INITIAL FIRE SAFETY INSPECTION REPORT

Factory Name: Tosrifa Industries Ltd (Extension)

RSC ID: 25788

Date: 20th Oct 2024

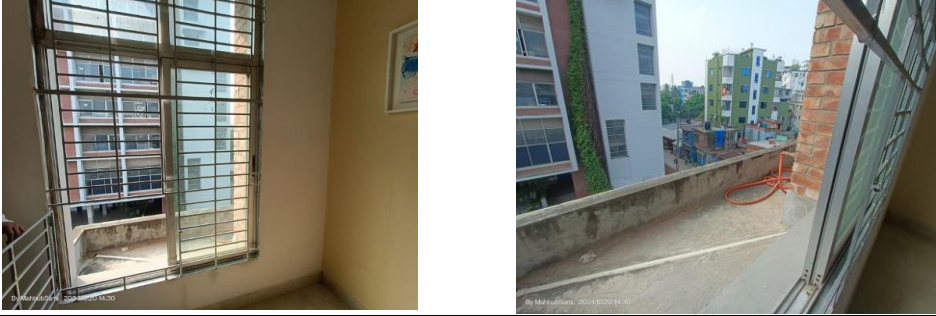
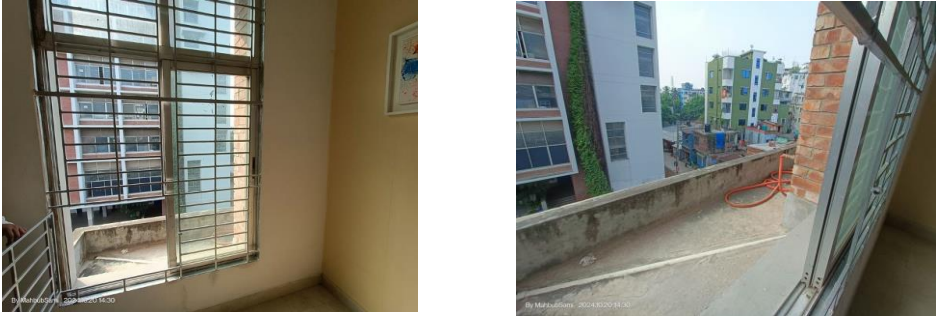
F-3	Fire Rated Construction	The main structural element of the building is constructed by steel which is non-rated and were found in exposed condition without any fire protection. Location: Kitchen Shed (Interim Construction; Height-18'08") & Boiler Shed (Interim Construction; Height-18'05").	For interim construction, the building shall be Type 1 or Type 2 construction as required in BNBC 2006 Part 3 Table 3.2.4. So, provide require rating for the structural elements of the building following BNBC 2006-Table 3.2.4, 3.1.9 and 3.3.1 & Section 4.4 and Table 4.4.1 of the RSC Technical Guidelines (Standard) V1. Consult a qualified fire protection engineer to design the rated construction barriers in between two floors and in structural members. Factory shall ensure that, all the design, datasheet, certificate, and the design-philosophy has been reviewed from the RSC prior to install the passive fire protection system.	Within 6 months
